MEMORANDUM

MEETING DATE: September 3, 2026

RE: Historic District Permit Application, 560 Mill Street

REQUEST: The applicant is requesting approval to enclose an existing covered porch connecting the garage to the home. Existing porch dimensions will remain the same and the current concrete stairs will be replaced with slate. Two (2) single pane windows will be installed on both the north and south sides of the enclosure with one (1) new stone white clad exterior pine door. LP Smartside Smooth Trip products are proposed to be used between the windows and doors.

North Elevation

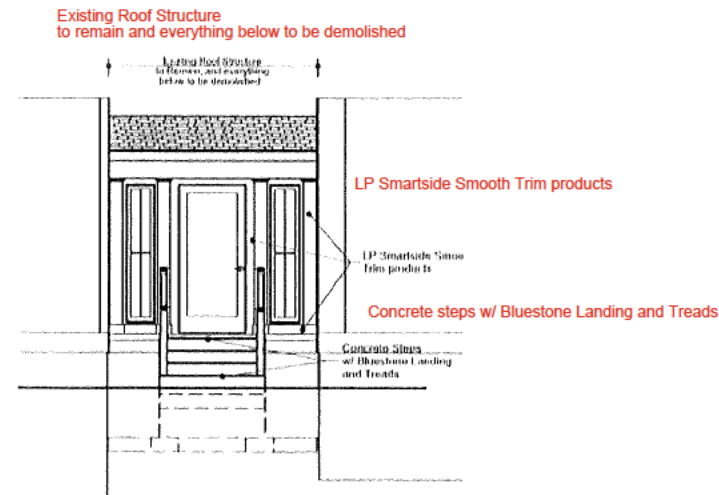
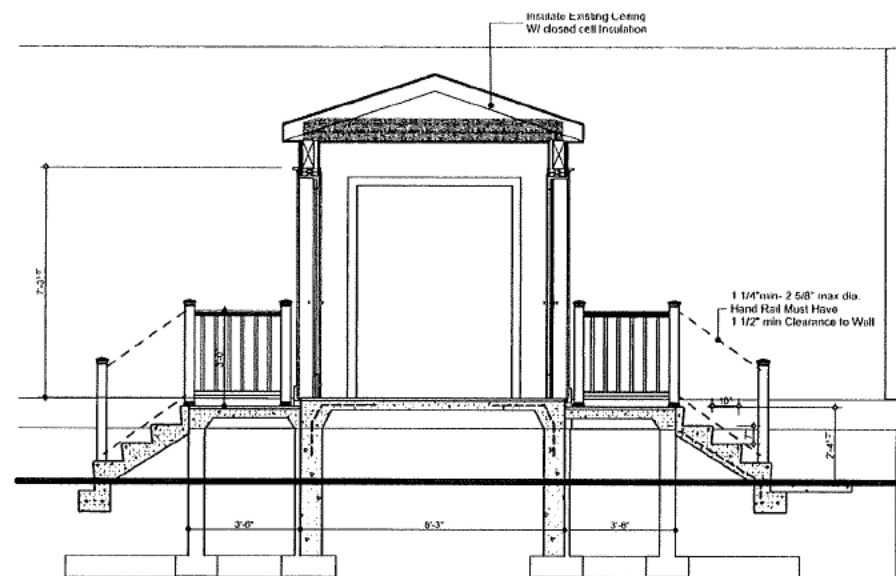
The applicant is proposing to enclose the existing covered porch connecting the garage to the home. The footprint and dimensions of the existing porch will remain unchanged. The proposed work includes installation of four (4) single-pane windows, two (2) stone white clad exterior pine doors, LP SmartSide Smooth siding between the proposed openings, and replacement of the existing concrete stairs with slate.

Because the proposal encloses an existing covered porch rather than creating a new addition with an expanded footprint, the Commission should consider whether the proposed enclosure maintains the existing spatial relationship between the home and garage and whether the scale, location, and design of the enclosure are compatible with the existing structure.

The proposed windows and door should be reviewed under the applicable provisions addressing doors and windows. In particular, the Commission should consider the location, size, proportions, materials, and overall appearance of the new openings and whether they are compatible with the existing structure. The proposed LP SmartSide Smooth siding should also be evaluated under the applicable provisions regarding substitute materials, including whether its use is appropriate for the proposed work and whether it would eliminate or obscure any architectural details.

The proposed replacement of the existing concrete stairs with slate should be evaluated for compatibility with the existing entry and surrounding materials. Overall, the Commission should consider whether the proposed improvements preserve significant existing features and maintain compatibility with the architectural character and historic context of the property and surrounding district.
